# SERVICE No. 308A BULLETIN

Piper Aircraft Corporation

Subject:

PA-31 and PA-31-300 Navajo

### Aft Facing Seats Placard

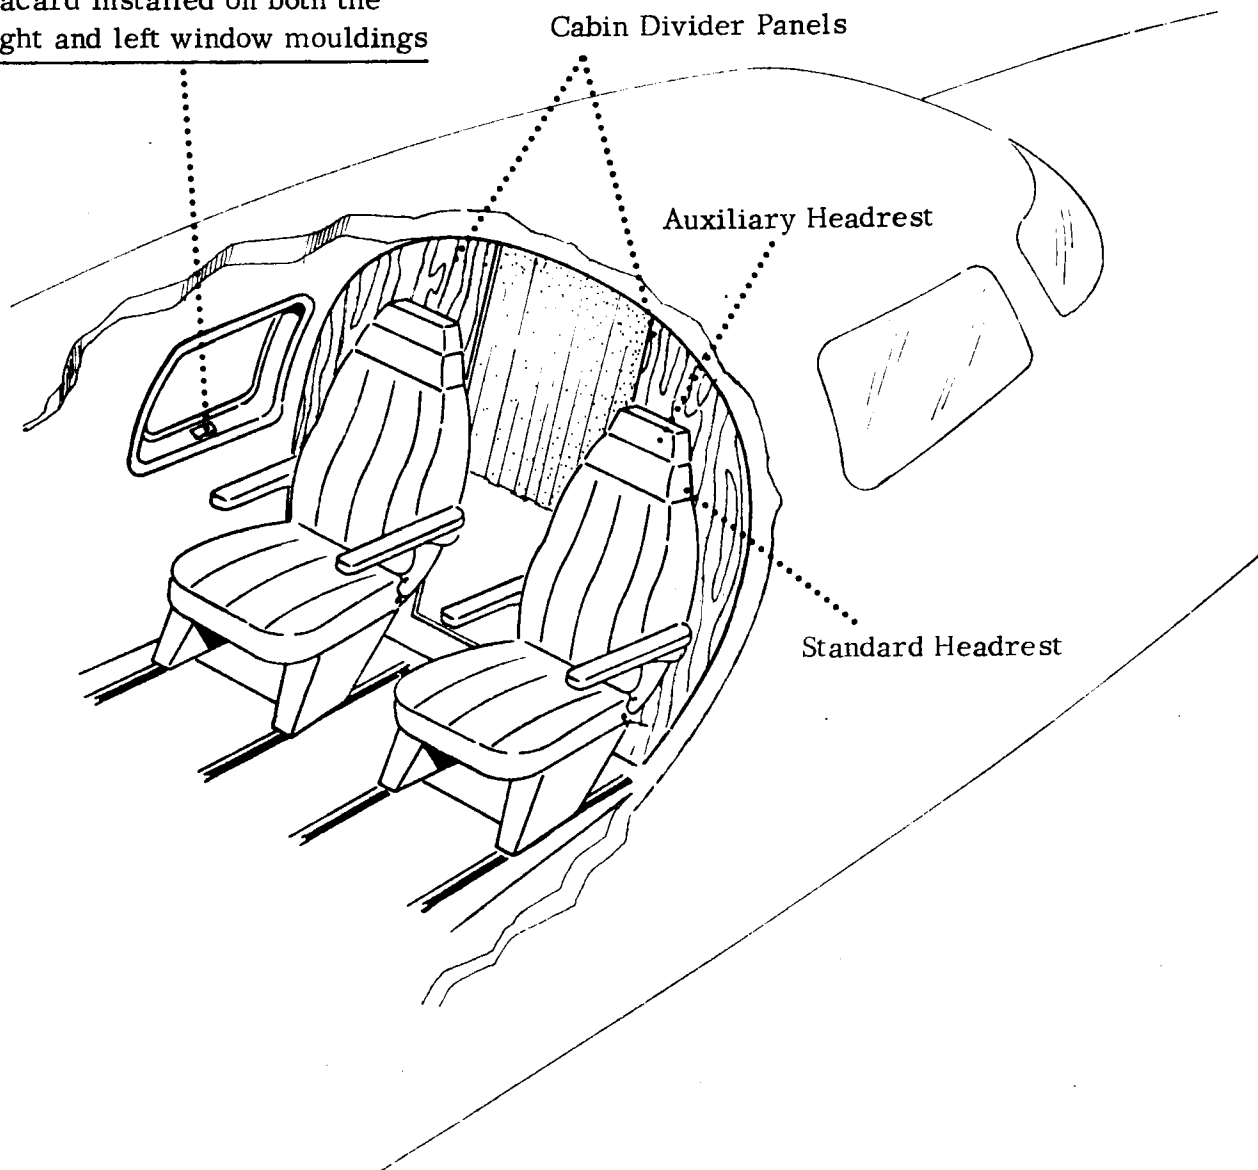
- III. Conditions for occupancy of the two forward (third and fourth) cabin seats during take off and landing, when facing aft, are as follows:
  - (1) Forward Cabin Divider Panels must be installed (reference sketch on page 3 of this bulletin).

- (2) The standard 6 inch seat headrest plus a 4 inch auxiliary headrest must be installed on seat and forward cabin divider panel respectively (see Material Required, number 2 below).

- (3) The seat back must be bolted in the upright position (instructions contained in applicable Auxiliary Headrest Installation Kit, reference Material Required, number 2, below).

III. (4) The seat must be positioned and latched in the most forward position (instructions contained in applicable Auxiliary Headrest Installation Kit, reference Material Required, number 2, below).

1. Seat Headrest (10" Min. Ht.) installed.
2. Seat Back bolted in upright position.
3. Seat latched at forward position.
4. Forward Cabin Divider Panel installed.

Placard installed on both the  
right and left window mouldings
